2022 Draft Final Blacktail Creek Groundwater Hydraulic Control System Remedial Design Work Plan

RE: Draft Final Blacktail Creek Groundwater Hydraulic Control System (BTC GWHC) Remedial Design Work Plan (RDWP)

**Response to Agency Comments to the
Butte Priority Soils Operable Unit (BPSOU) Draft Blacktail Groundwater Hydraulic Control
System Remedial Design Work Plan**

Date of Comments: September 29, 2022

SITE LOCATION MAP

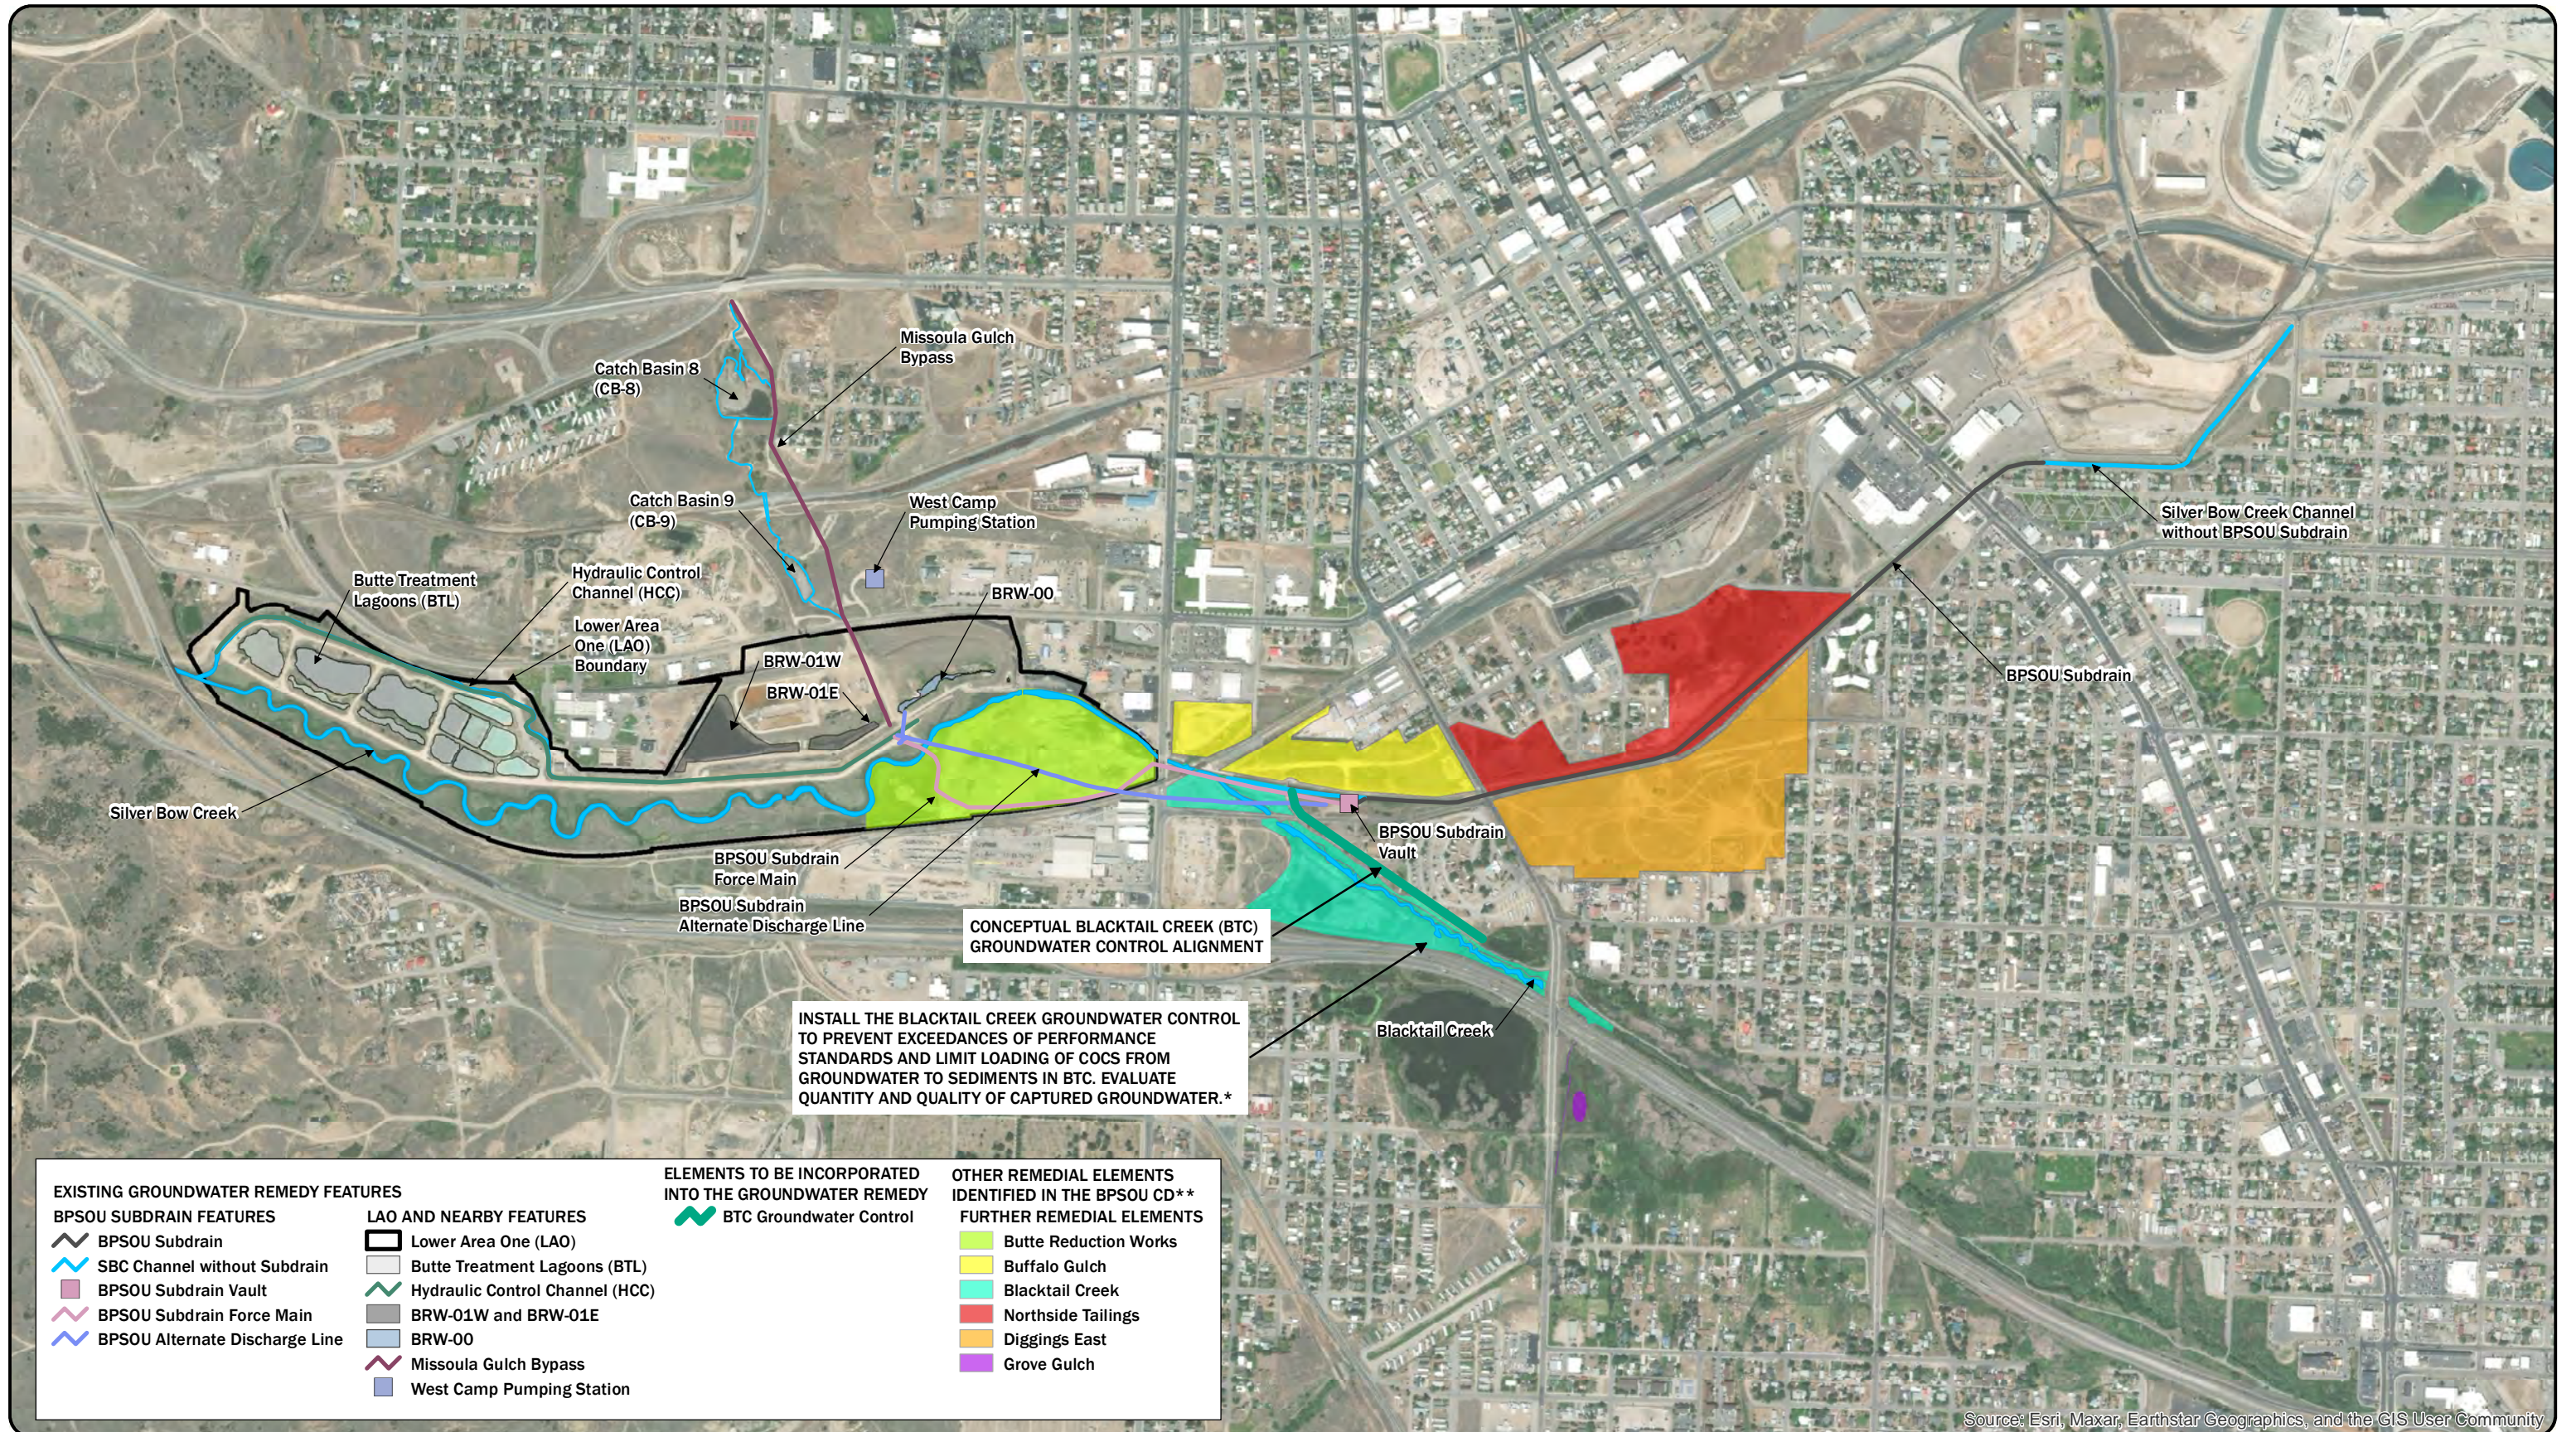
EPA Specific Comment 23a (Figure 1): Site Location Map. Compared to other RDWPs, the projection/zone, datum, units, and source differ from figure to figure. Is there a way to be consistent between figures, both in what datums are listed and in naming convention?

EPA Specific Comment 23b (Figure 1): The state location inset map does not provide great value to the figure, as it does not do a good job of specifying the project location. Please consider highlighting Butte in the inset map to help clarify the project location.

EPA Specific Comment 23c (Figure 1): Please define TI Zone in Acronyms list.

Atlantic Richfield Company Response: All maps have been updated with consistent projection/zone, datum, units, and source.

Atlantic Richfield Company Response: Butte is now highlighted in the inset map.

Atlantic Richfield Company Response: "TI Zone" has been added to Acronyms list as requested.

SITE OVERVIEW AND BLACKTAIL CREEK GROUNDWATER CONTROL SYSTEM CONCEPTUAL REMEDIAL DESIGN

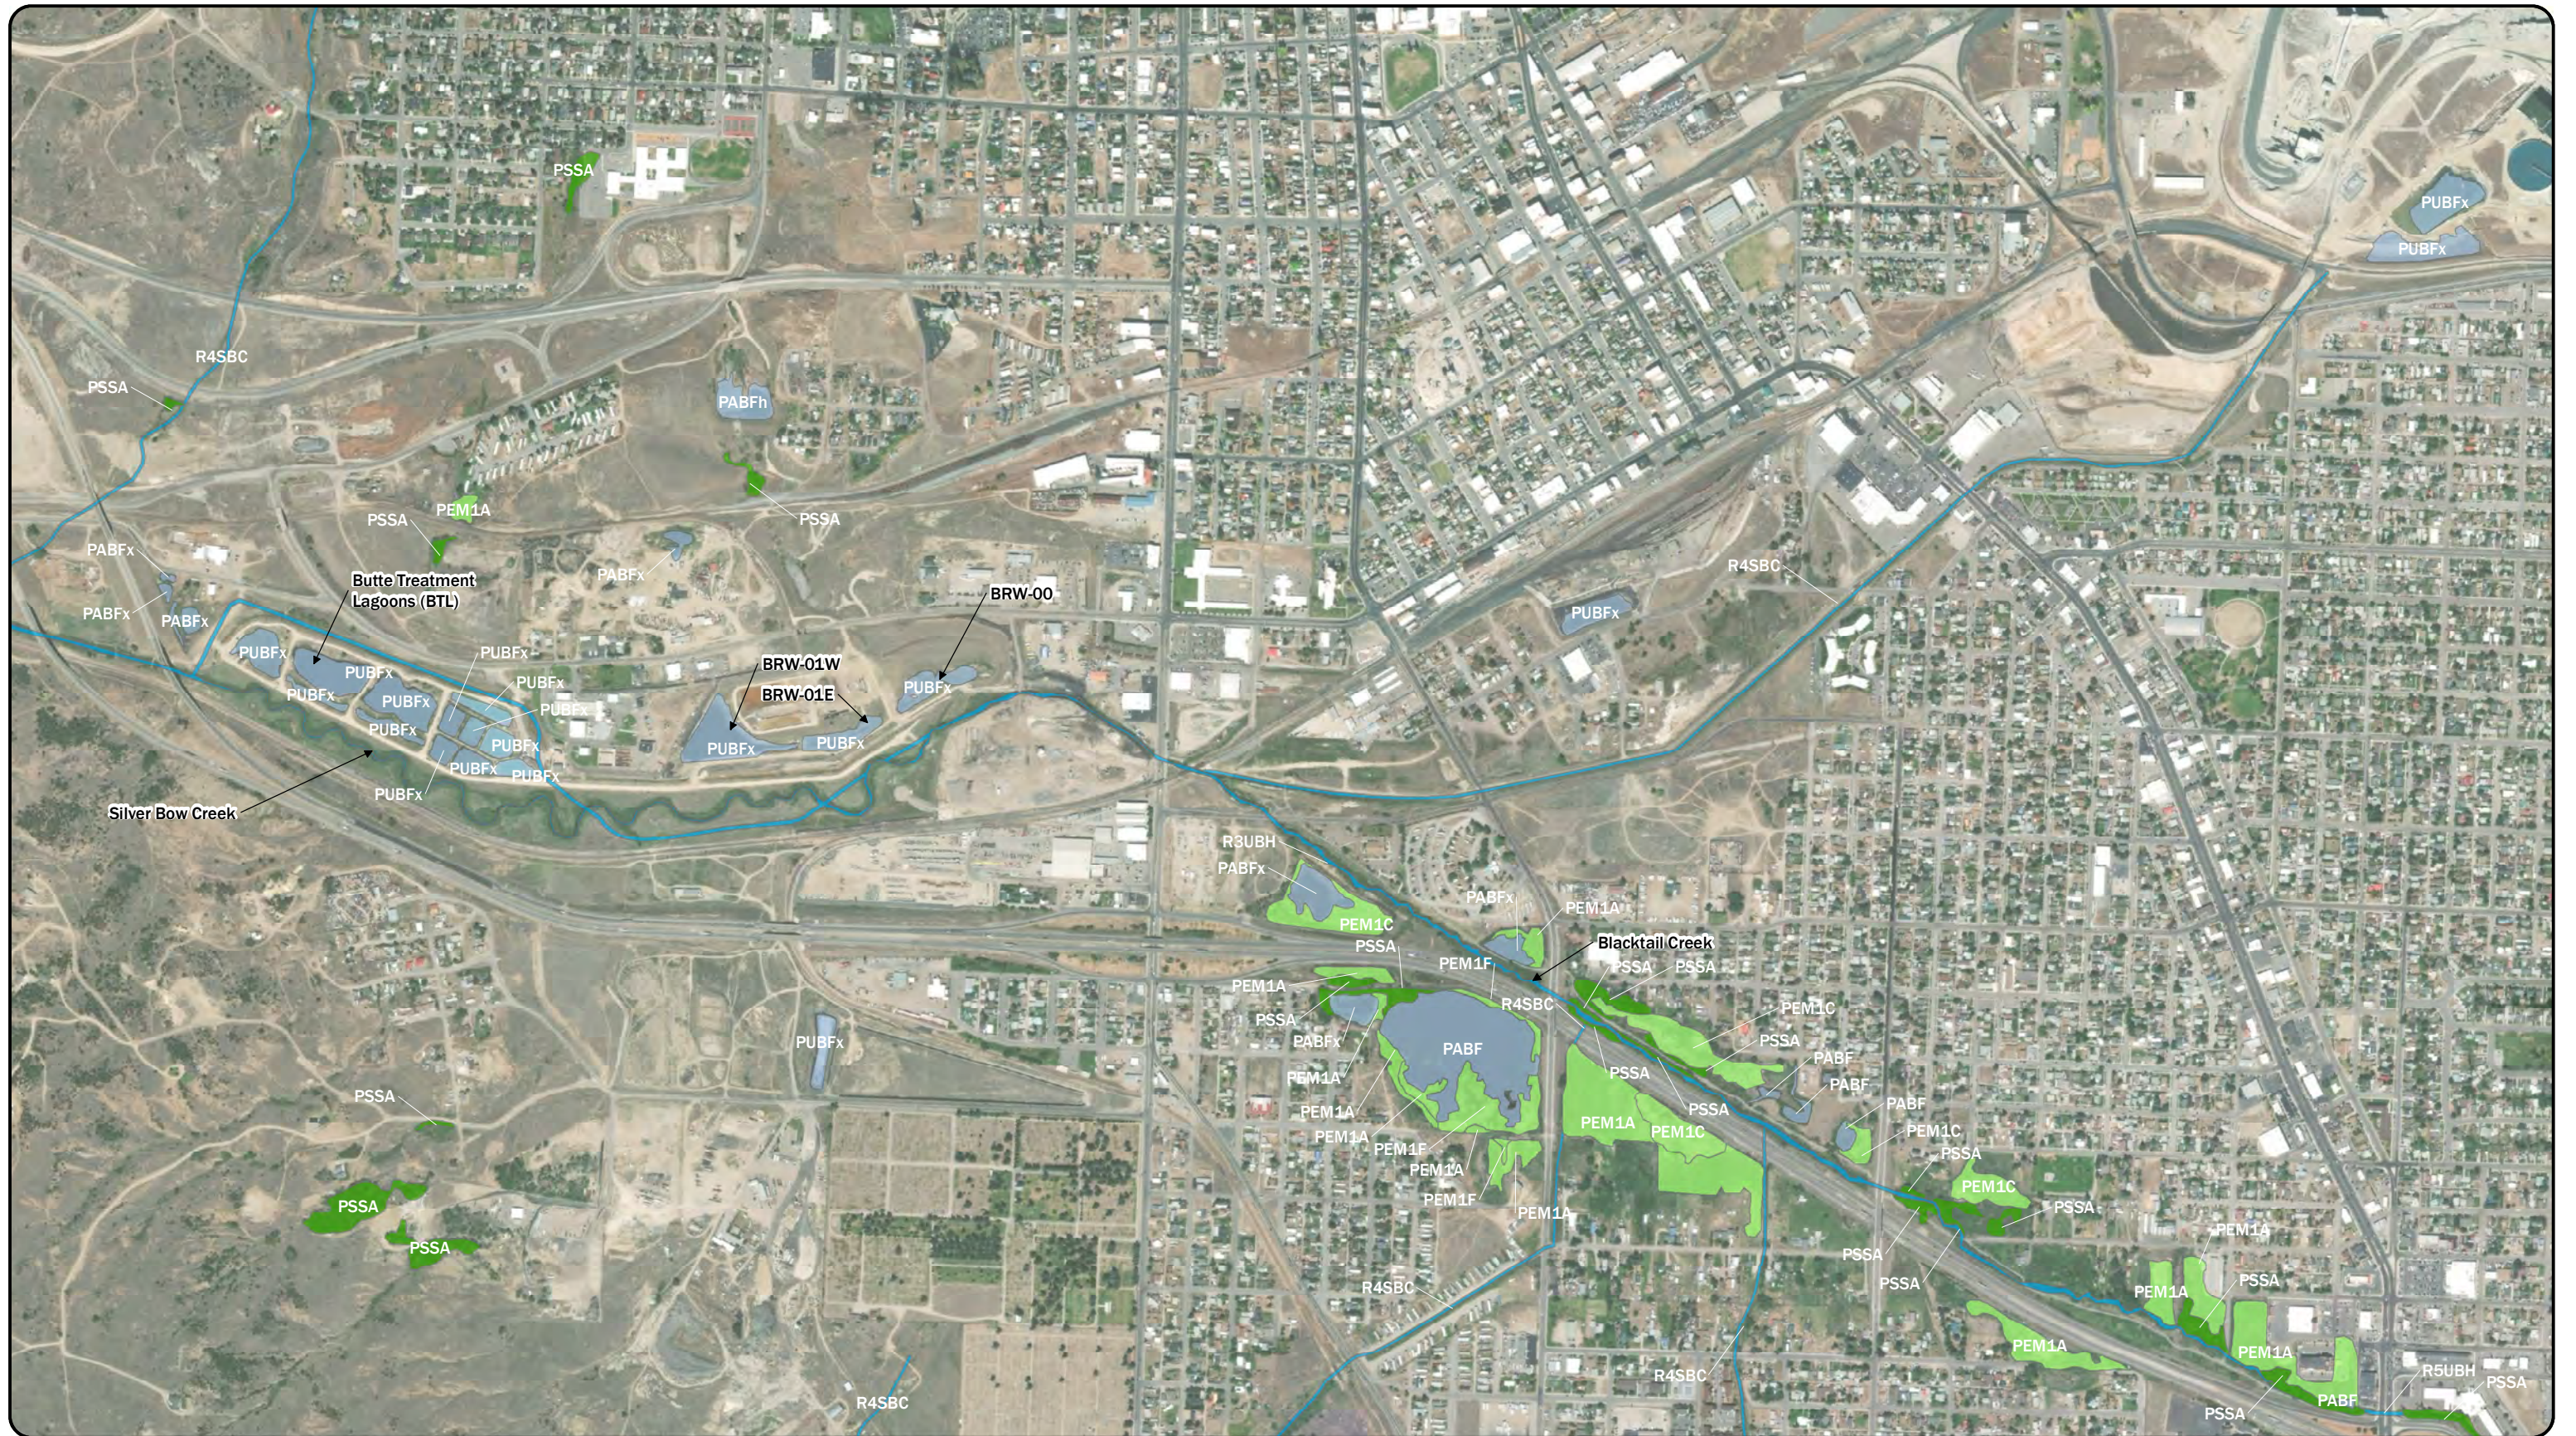
EPA Specific Comment 24 (Figure 2): Site Overview and Blacktail Creek GHCS Conceptual Remedial Design. There are no projection/zone, datum, units, or source listed. Please be consistent with *Figure 1*.

Atlantic Richfield Company Response: All maps have been updated with consistent projection/zone, datum, units, and source.

Figure 4. Project Organizational Chart

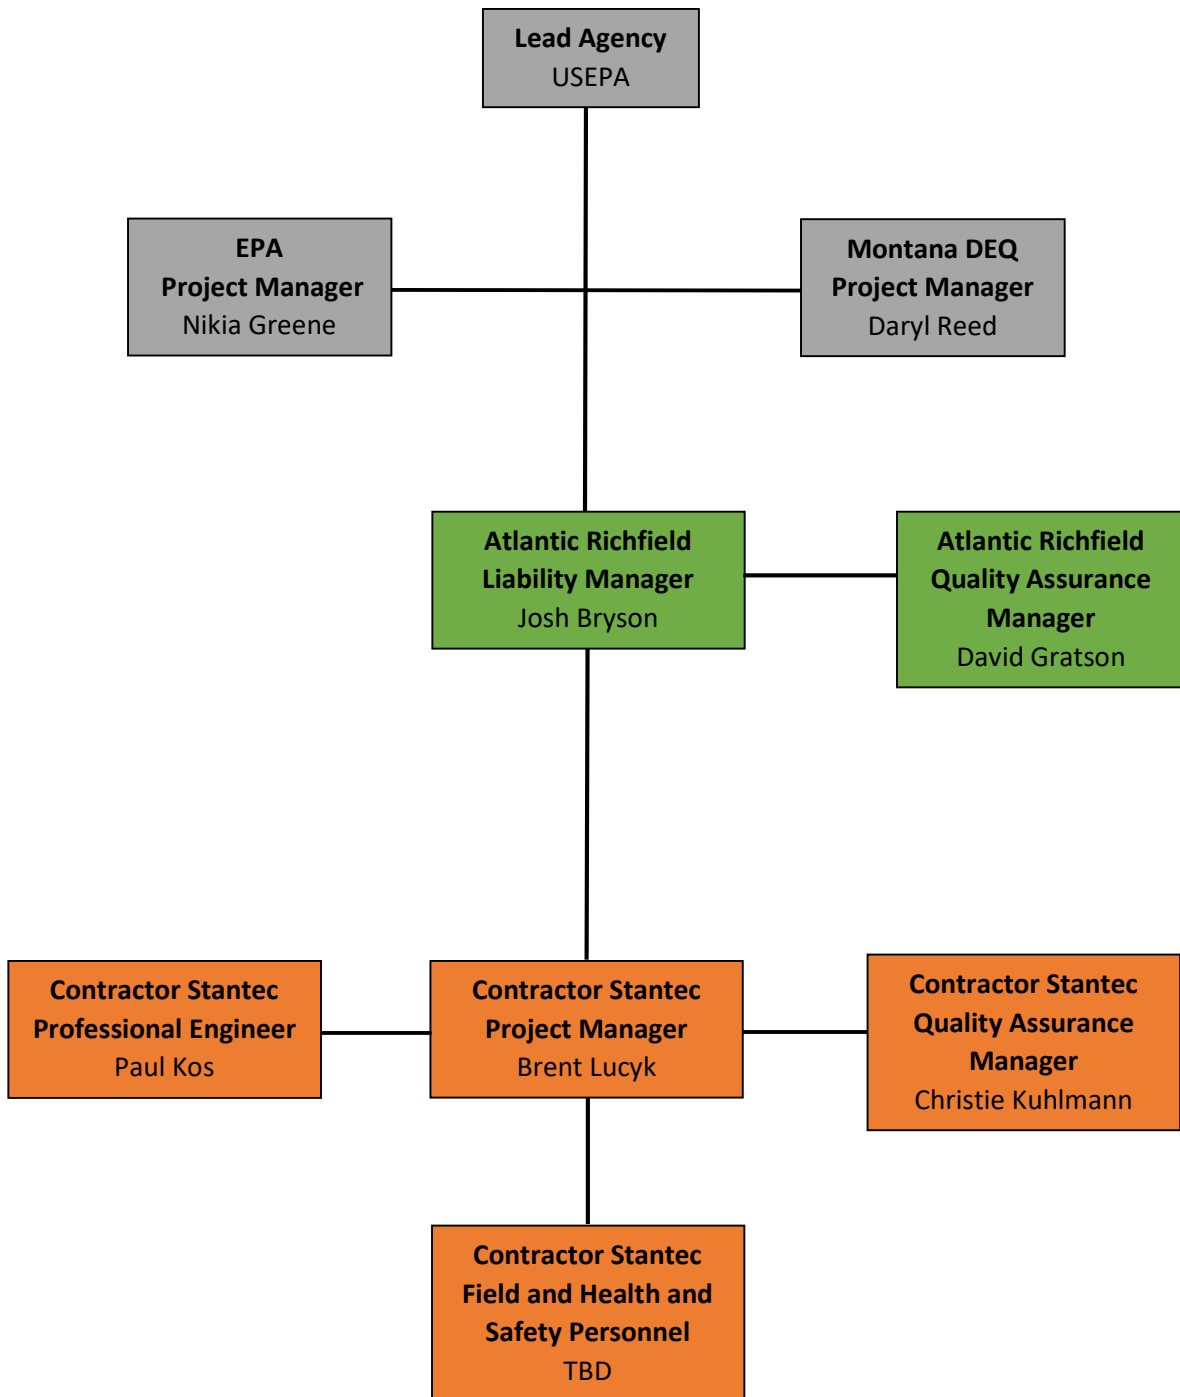
EPA Specific Comment 11 (Section 4.0 Project Organization): Please consider adding a hierarchy chart (hierarchy diagram) to portray the key organizations involved with developing/implementing the RD. This would help the reader to quickly visualize the top-down modular breakdown of the entire system.

EPA Specific Comment 15 (Section 4.2 Key Personnel): As with the comment above, please consider adding a hierarchy chart (hierarchy diagram) to portray the key personnel involved based on their roles and responsibilities. This would help the reader to quickly visualize the top-down modular breakdown of the entire system.

Atlantic Richfield Company Response: A project organizational chart with key personnel’s roles and responsibilities has been included as Figure 4.

Atlantic Richfield Company Response: A project organizational chart with key personnel’s roles and responsibilities has been included as Figure 4.
